TO: PLANNING COMMISSION

**SUBJECT: DESIGN REVIEW – SITE PLAN REVIEW – DRIVEWAY APPROACH
PERMIT
PERMIT CASE NO.19-12; 4485 KALE ROAD NE
AMANDA NOS. 19-122763-DR, 19-122762-RP AND 19-124614-ZO**

Summary: Proposed development of a new 324 dwelling unit multi-family apartment complex with associated parking, play and recreation areas, landscaping, and common building.

SITE PLAN

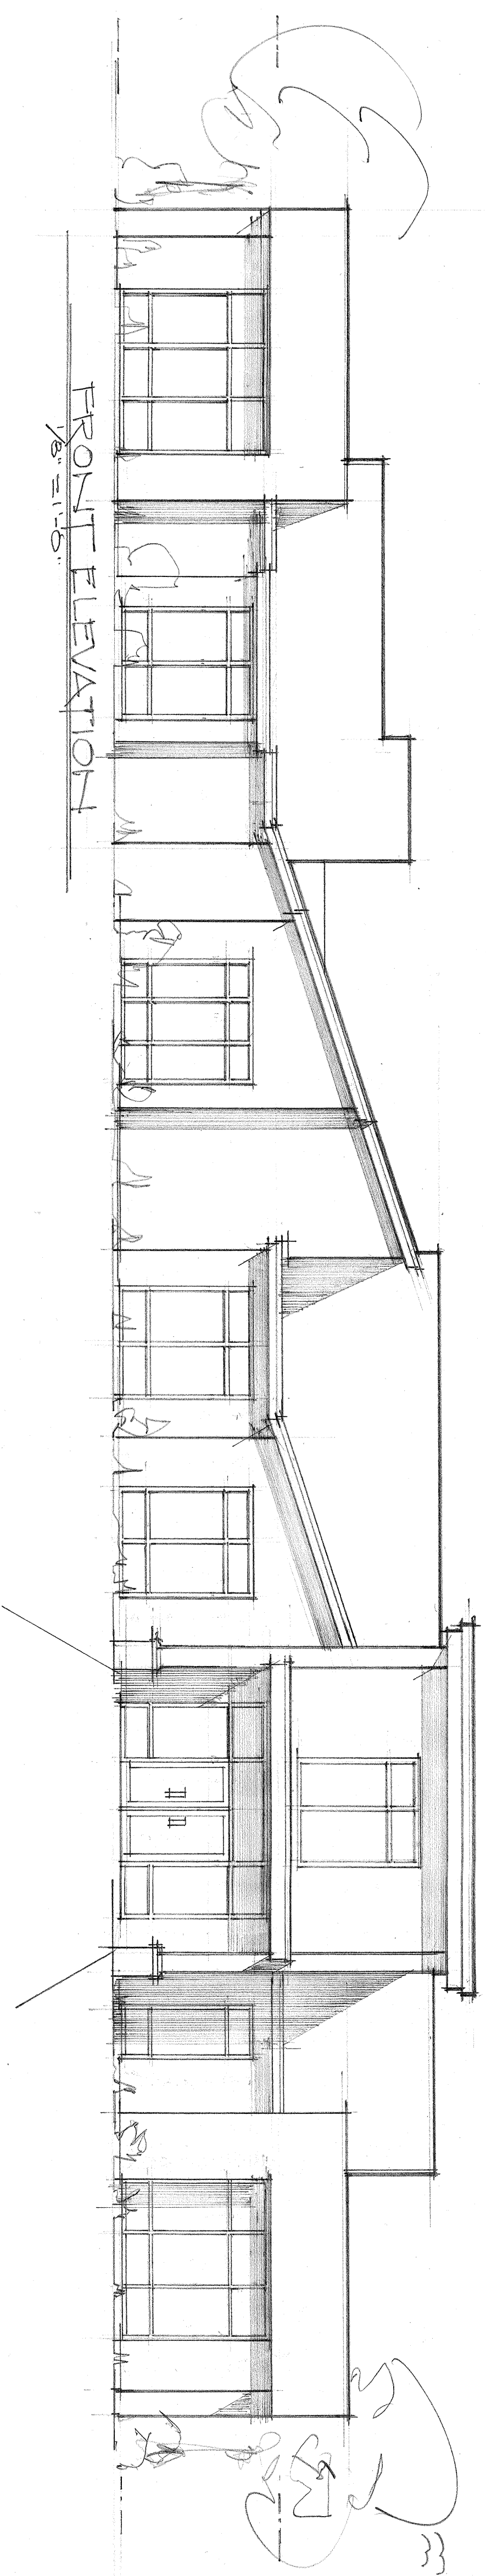
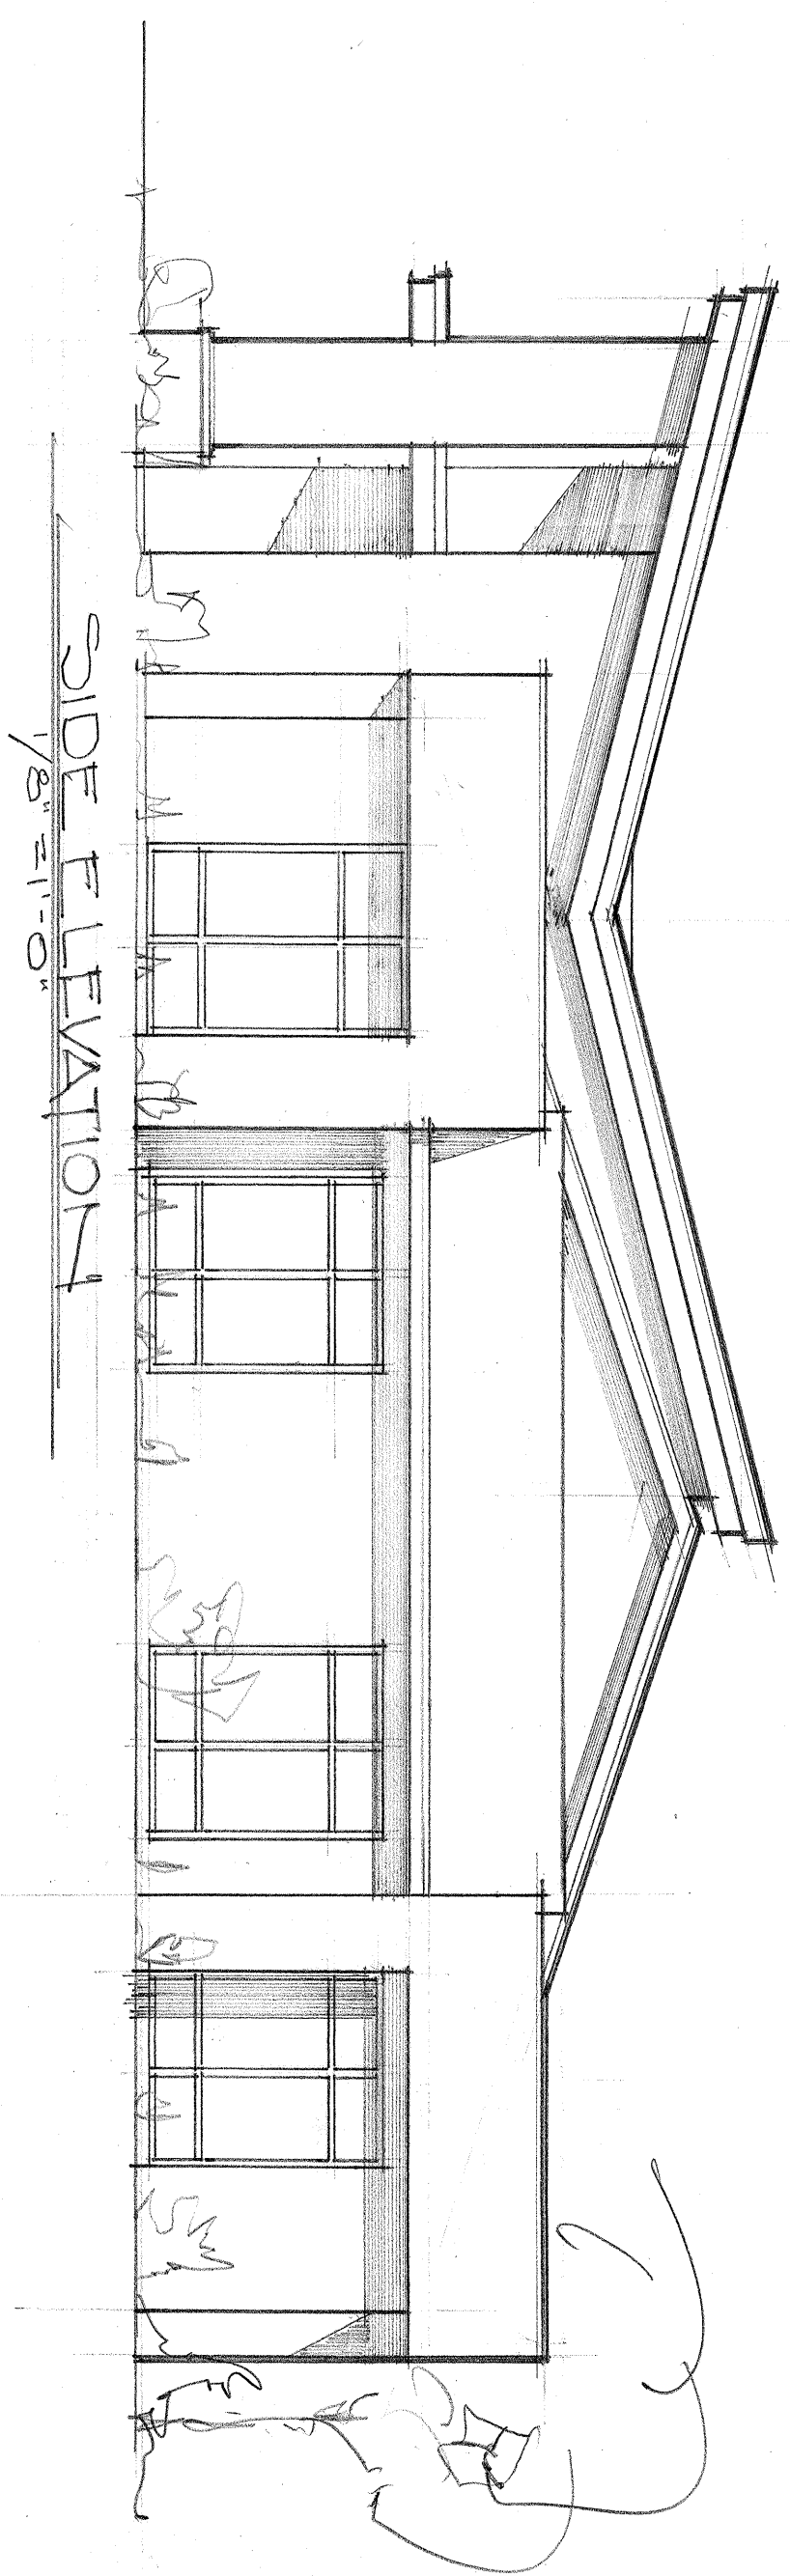
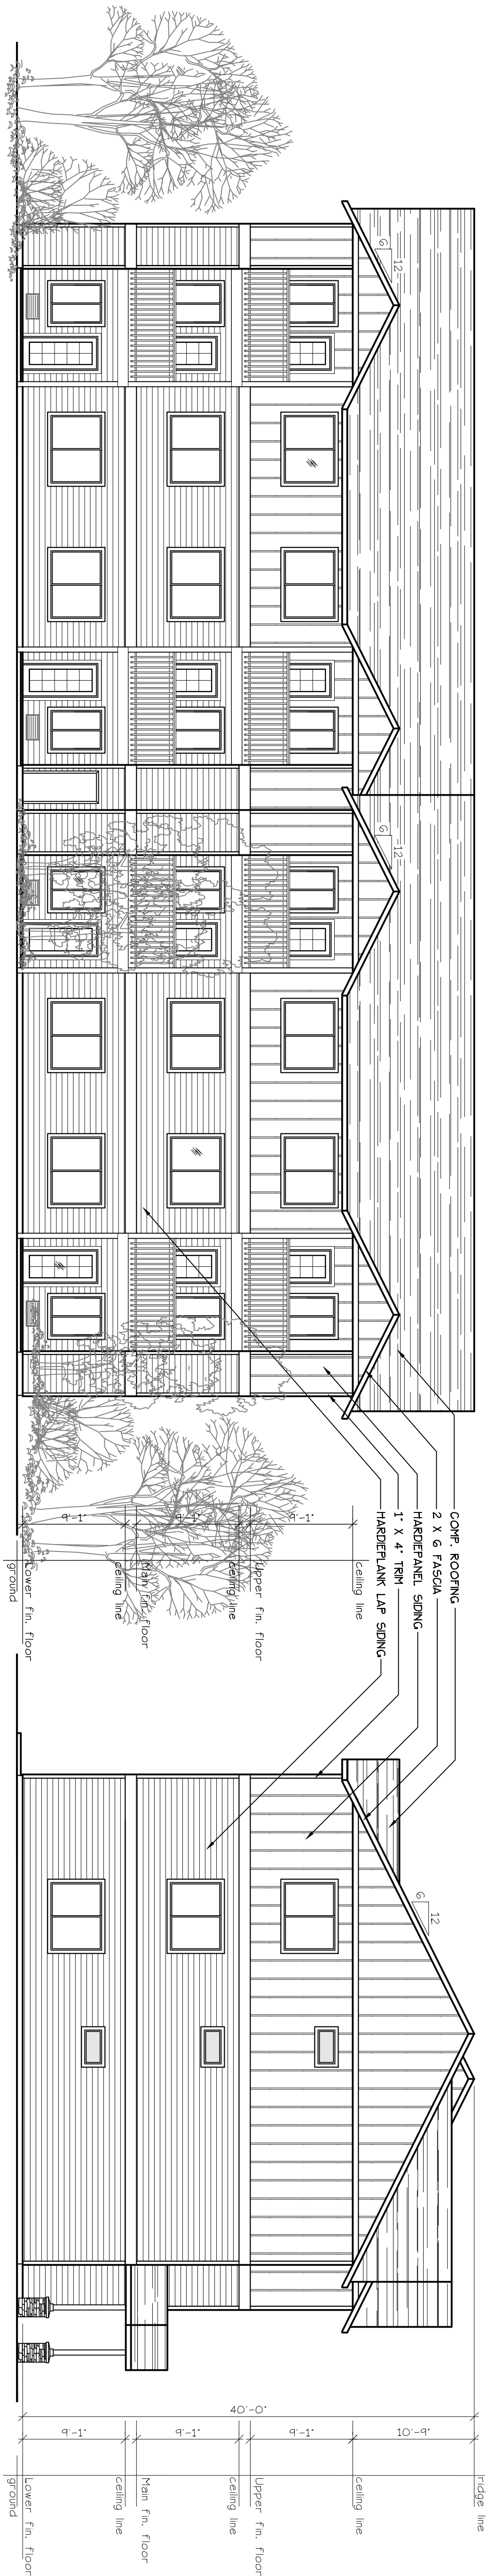
Finding: The proposed site plan includes pedestrian pathways which connect the parking areas, common open space areas and dwelling units to the public right-of-way. However, the site plan lacks a pedestrian connection to the City park north of the subject property (Hazelgreen Park). The park is an abutting use which should be connected to the large development in multiple locations. The park can be accessed from Countryside Drive. The Parks Division has determined an additional connection through the development site is needed to best serve the public. In addition, the size of the subject property would require a street connection to meet SRC 803.030(a) through the property to the north property line. Since the applicant is requesting an alternative street standard to eliminate the street, and there is a need for the public to access Hazelgreen park, a public easement would meet the alternative street standard and the pedestrian connectivity to the park.

The site can provide a public easement that is 10-ft wide, to include a five-foot landscaping area and a five-foot sidewalk through the site. The five-foot landscaping area would be located between the sidewalk and the parking lot which would provide pedestrians a buffer from the parking area. The recommended condition would follow the proposed sidewalk location and would need to make the connection (striping) across the parking area to the north in order to connect with the park, which is north of the subject property.

Condition 3: The applicant shall provide a 10-foot public easement from Countryside Drive to the southern boundary of Hazelgreen

GARAGE 2 (15 GARAGES)

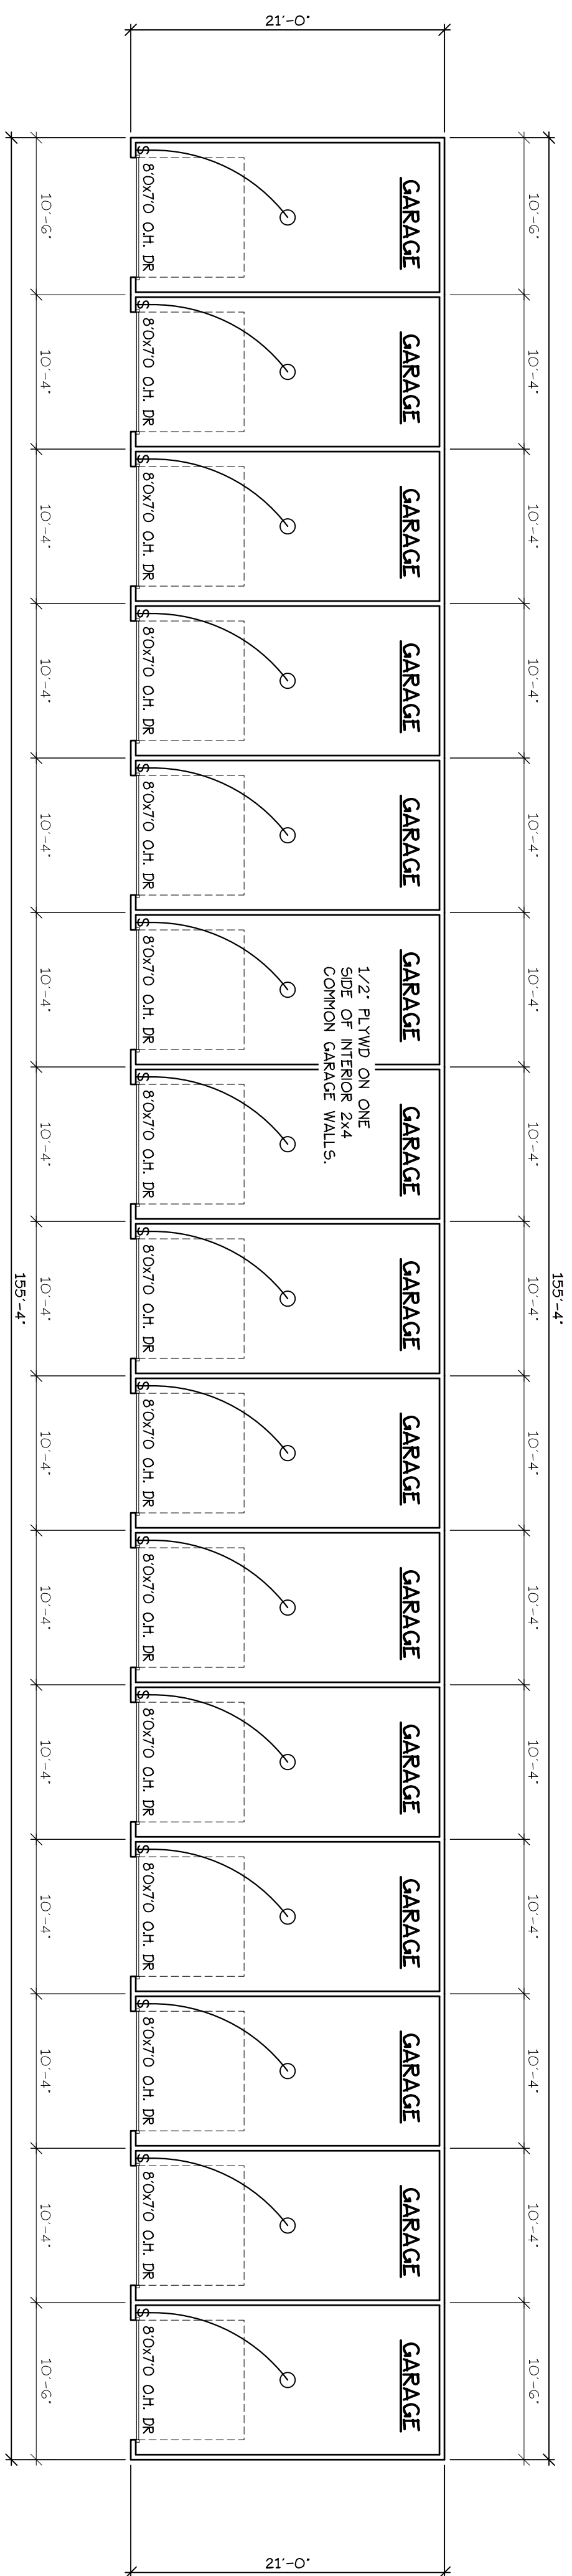
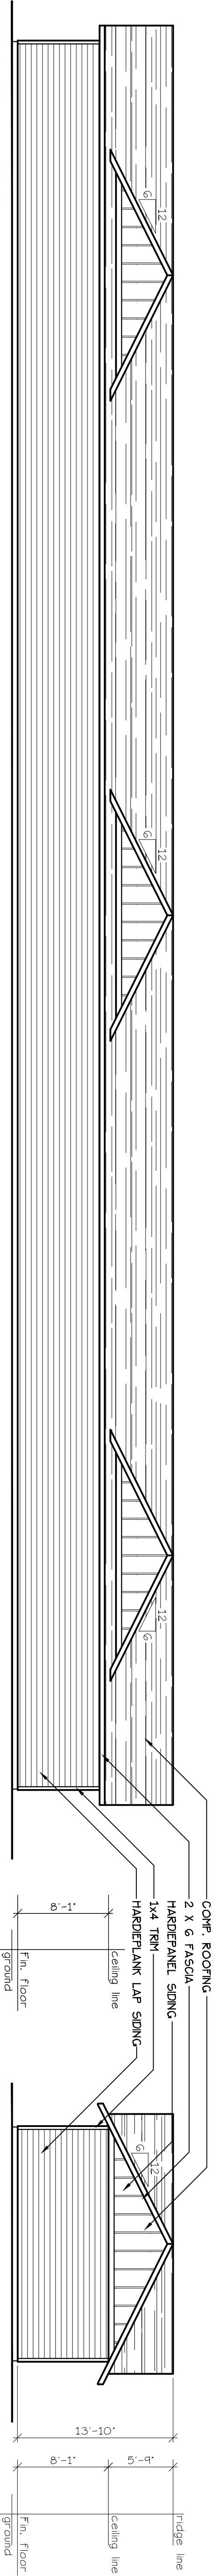
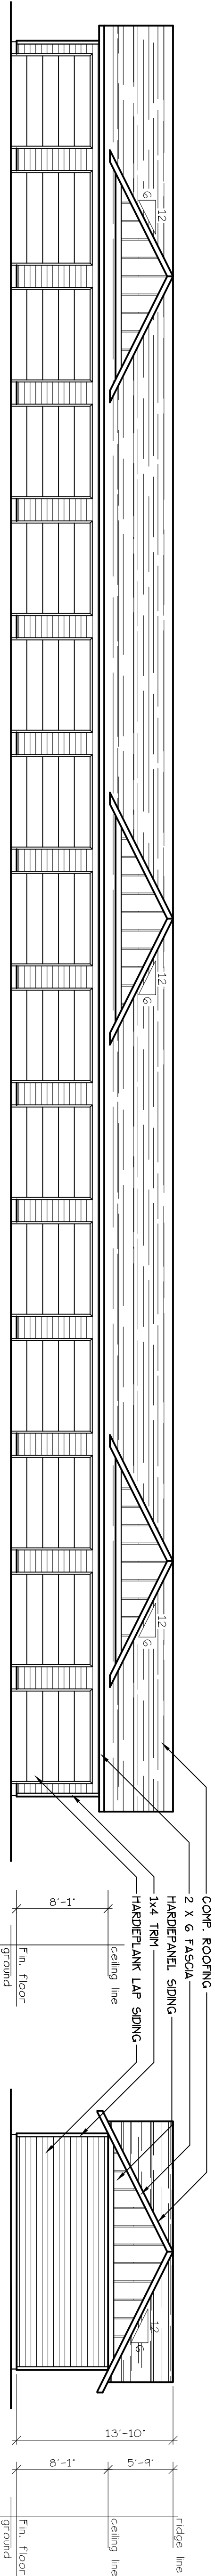
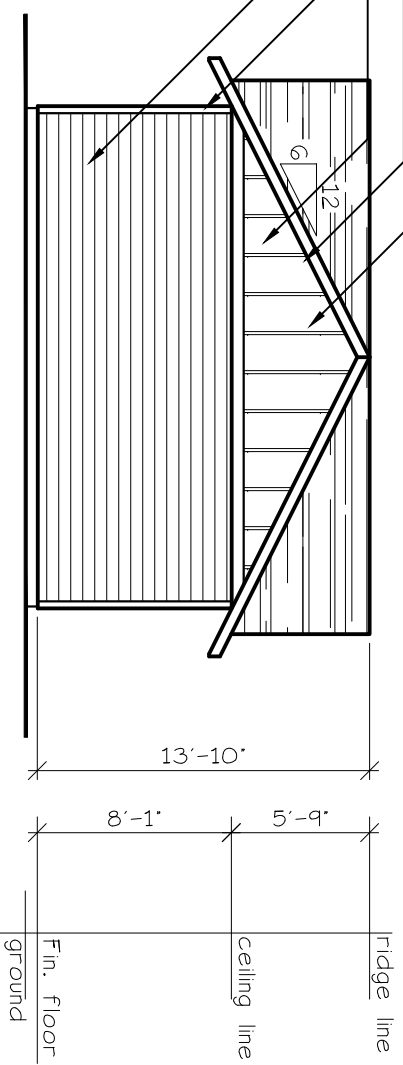
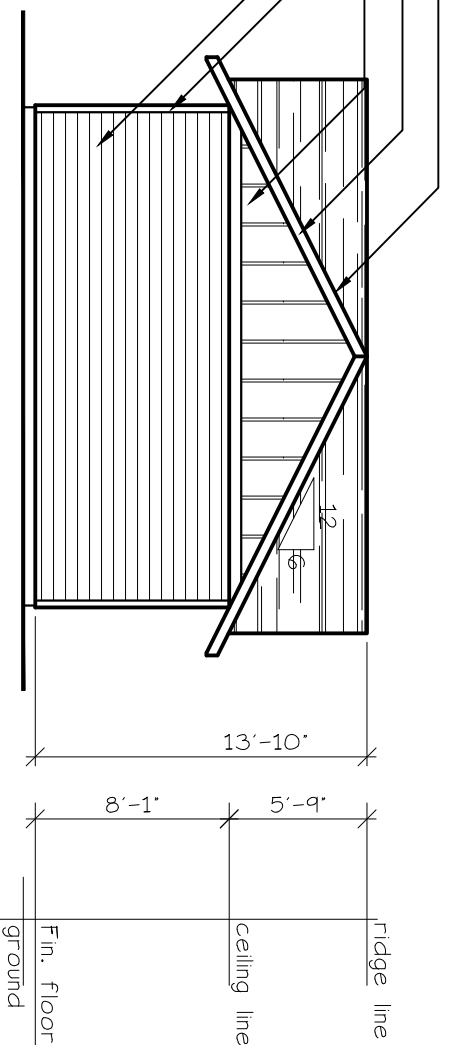
standard. The proposed recreation building has articulation along the floor plan which breaks up the exterior walls meeting the guideline. The proposed Garage 2 and 3 exceed 150-feet in length and do not provide any articulation along the walls. The walls of the garages are long and monotonous, therefore to meet the guideline without altering the floor plan the following condition is recommended:

- Condition 4:** Garage 2 and 3 shall provide contrast and distinction by incorporating one or more of the following on at least 75 feet of the buildings:
- a) Vertically oriented lap siding, or horizontally oriented lap siding that is wider than that provided on the upper floor facades or is painted a different color than the upper floor facades; or
 - b) A siding material different from that used in the other portions of the building facades.
